Product Change Notification / NTDO-09RUGQ249

CCB 4645 Initial Notice: Qualification of MPHL as additional final test site for selected ATSAMA5D3xA device families available in 324L LFBGA (15x15x1.4mm) package.

PCN #: NTDO-09RUGQ249

Cover Tape for T/R

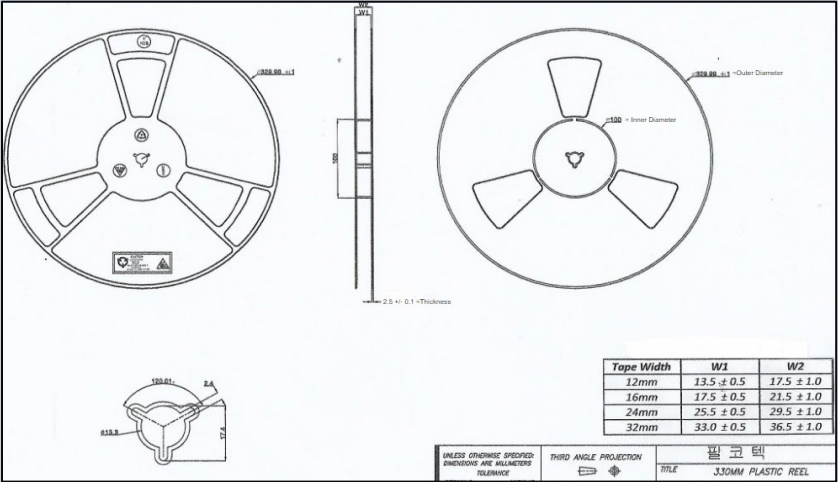
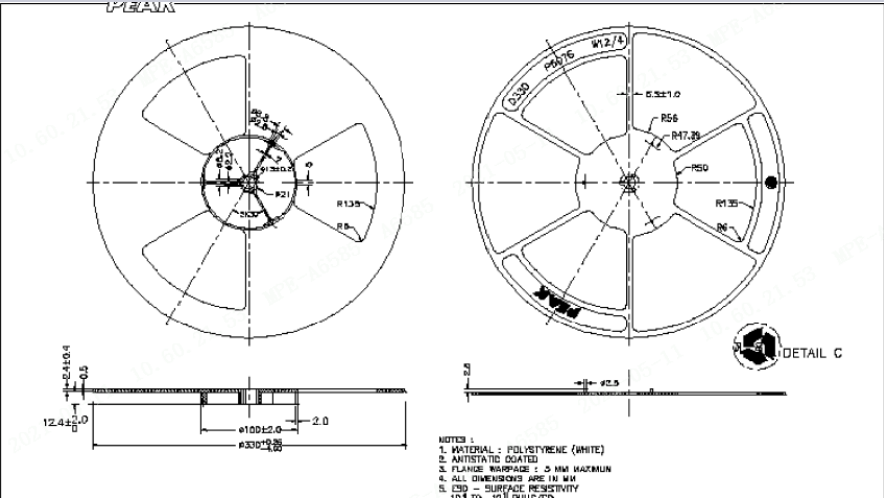
Corporation (MPHL)
Base Quantity Multiple (BQM)	T/R	500	500	500
	Tray	126	126	126
Pin 1 orientation		Quadrant 2	Quadrant 2	Quadrant 2
Carrier Tape		No dimensional changes*		
Cover Tape		Minor dimensional changes*		
Plastic Reel	Dimension	No dimensional changes*		
	Color	White	White	White
Tray	Dimension	No dimensional changes*		
	Color	Black	Black	Black
Packing Method		See attached Pre and Post comparison

Width W (mm.)	Thickness T (mm.)	Sealing Methodology
21.3	0.048-0.058	Heat Active Type

Width W (mm.)	Thickness T (mm.)	Sealing Methodology
21.3	0.045-0.055	Pressure Seal Activated
